Department of Environmental
Conservation

December 21, 2015

Re: Baker Oil Tools - Delores Drive
ADEC Hazard ID: 25935
Baker Hughes Nikiski Completions Facility
ADEC Review comments on Phase II Site Characterization Report October 15, 2015 and
Progress Report – Routine Ground Water Monitoring November 6, 2015

August 2015 Quarterly Groundwater Monitoring Baker Hughes Nikiski Completions Facility Nikiski, Alaska	Groundwater Elevations and Inferred Contours		Figure
	1 inch = 80 feet	November 16, 2015 DRAWN: CDH	AES.5001.01 CHKD: DJF	2

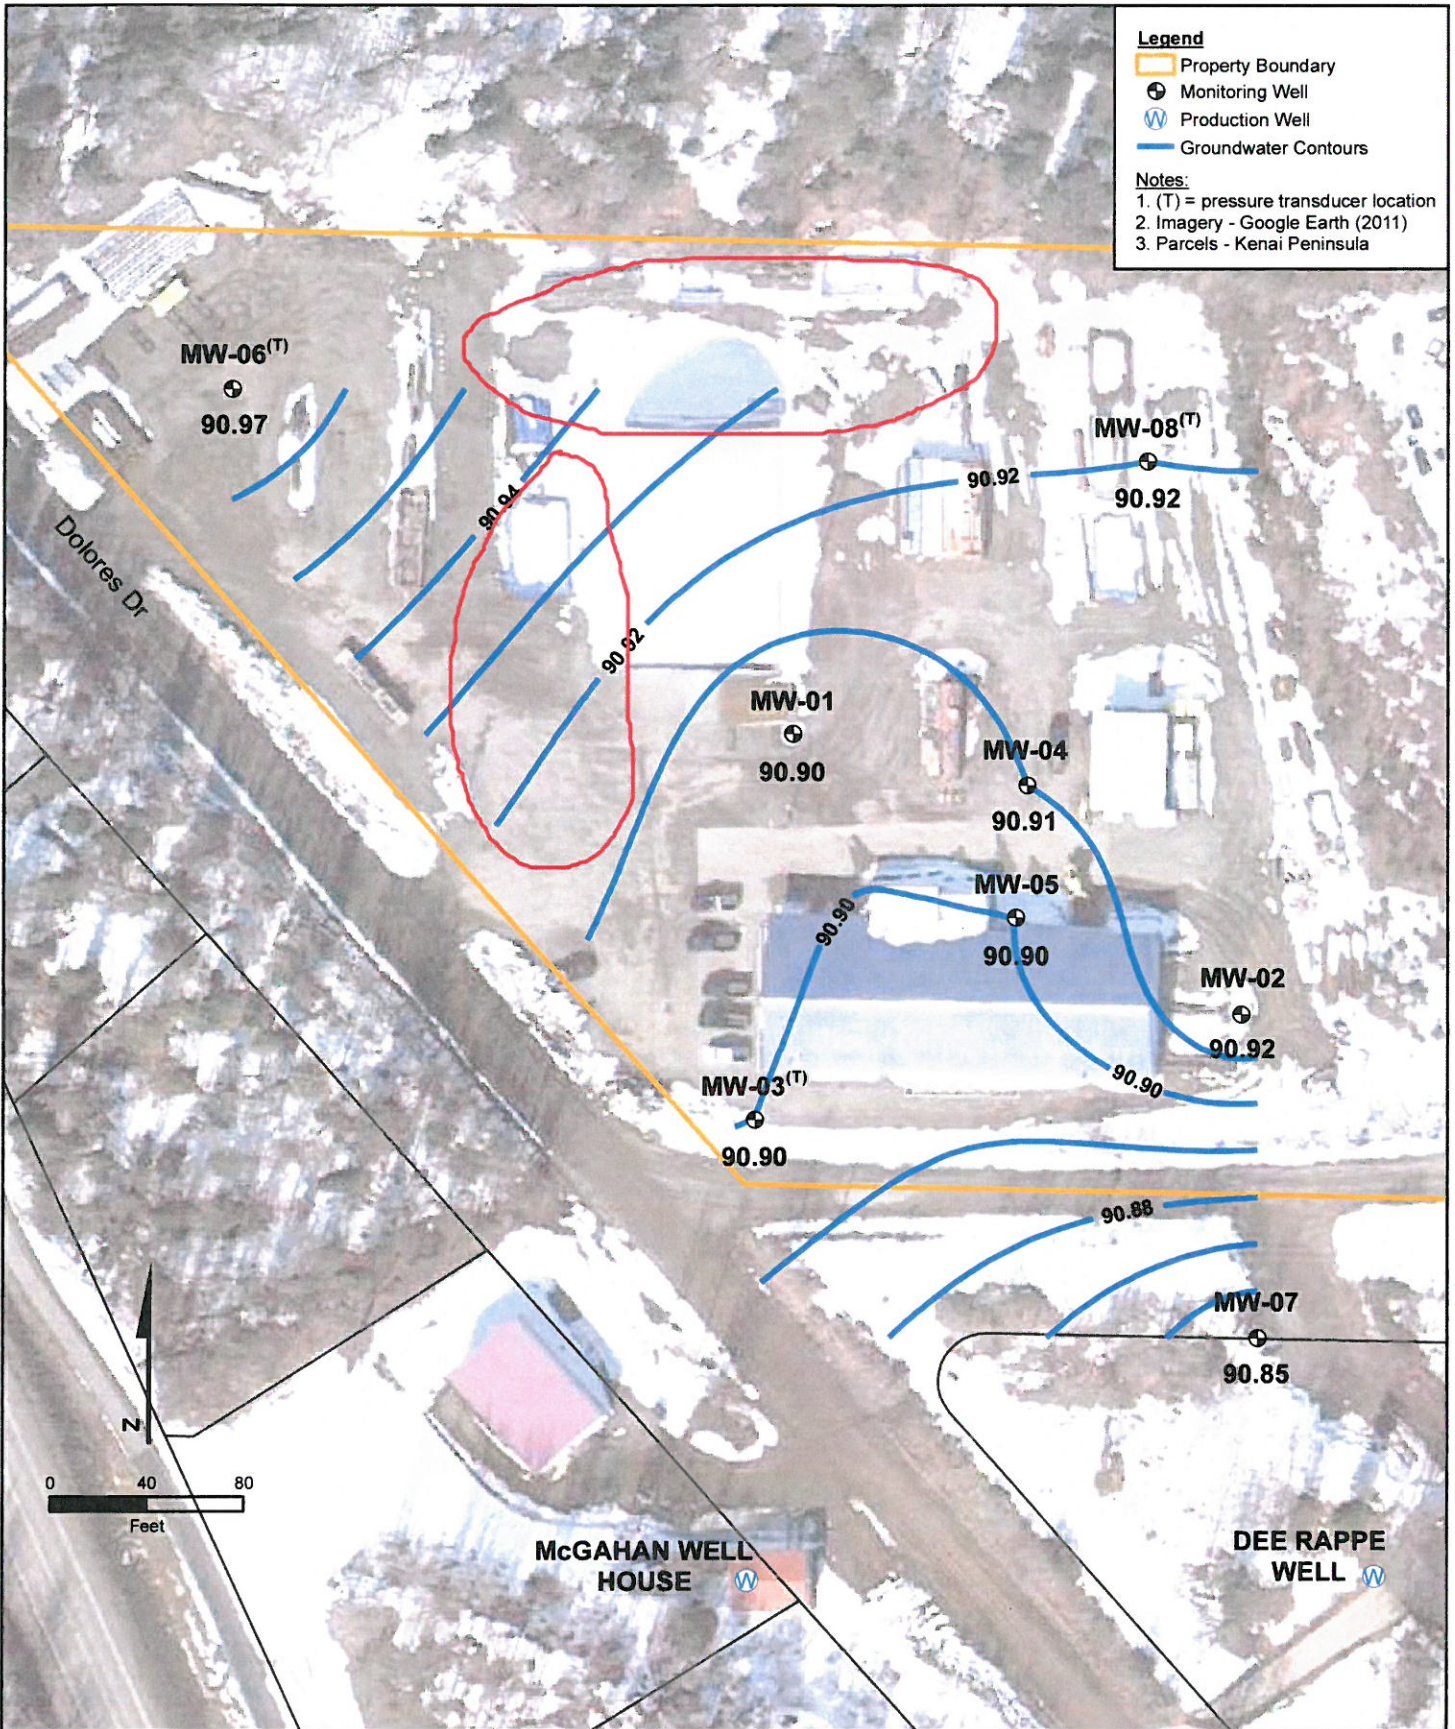
The unusually flat water table gradient of this aquifer may be influenced by the Nikishka Bay Utilities production wells. These wells withdraw groundwater at high rates, and may drawdown the water table in a manner that creates concentric groundwater elevation contours around the pumping wells. This was identified in the 1989 Hart Crowser investigation. The Hart Crowser elevation survey included additional groundwater elevation data points collected across greater distances, encompassing a larger area. This allows small groundwater gradients to be measured with greater certainty and accuracy. Their survey includes ADEC's MW-1, former MW-4, and the original McGahan Utilities' well.

The water level contour maps presented in your reports show a southerly groundwater gradient. This may be a consequence of the high pumping rates of groundwater withdrawal from the Nikishka Bay Utilities production wells, however our understanding of the regional groundwater flow in the area, is that groundwater most likely flows to the north.

Attachment: Figure 2 Groundwater Elevations and Inferred Contours with ADEC modifications
